**Re: Plea to Council for Protection against DA Modification No: 10.2018.466.2 (61 Kingsley St, Byron Bay).**

**Re: DA Modification No: 10.2018.466.2 (61 Kingsley Street, Byron Bay):**

## **Submission to Council ( Re: DA Modification: 10.2018.466.2 )**

Sheet No  
WD5.0

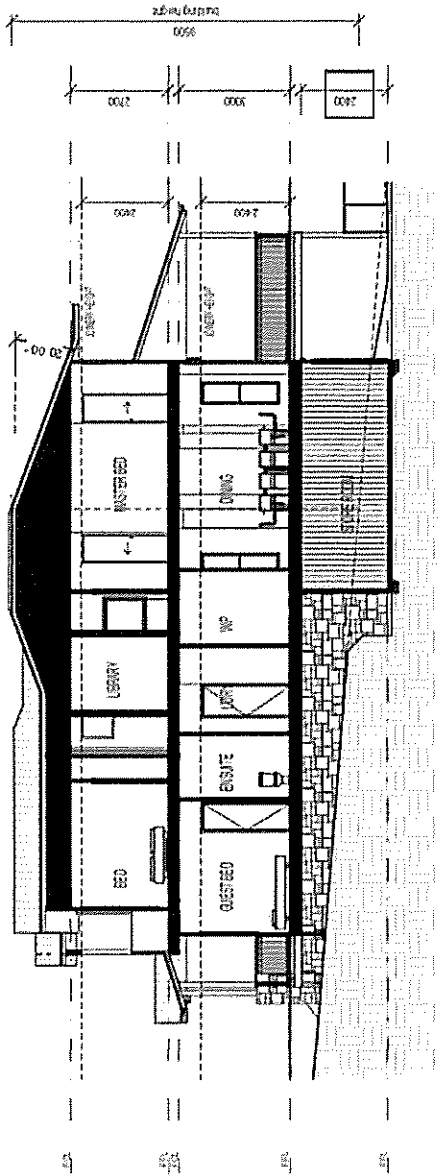
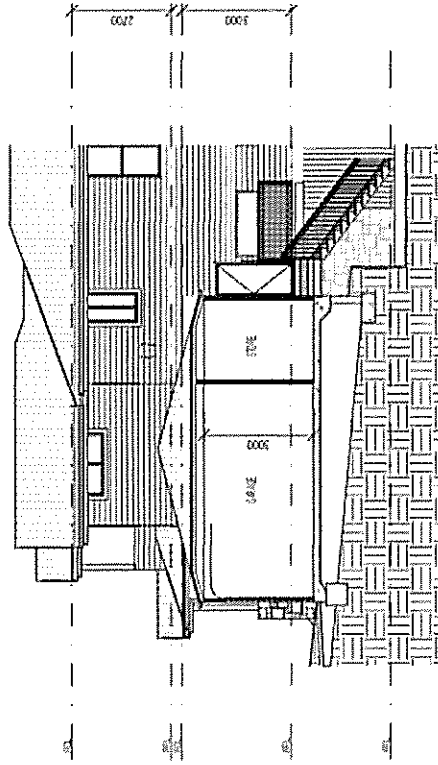
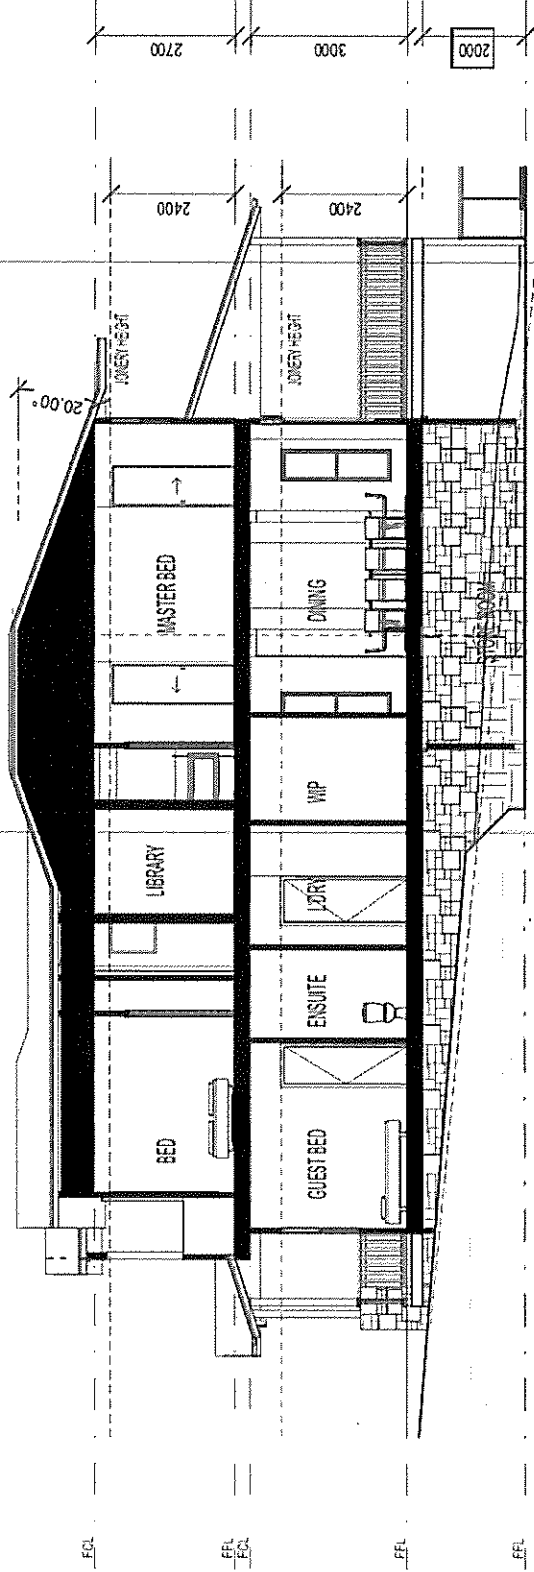
ISSUE A:  
2400 STORE ROOM HEIGHT  
ISSUE E:  
2000 STORE ROOM HEIGHT  
(GROUND FLOOR PLAN AND ELEVATION  
DISCREPANCY)
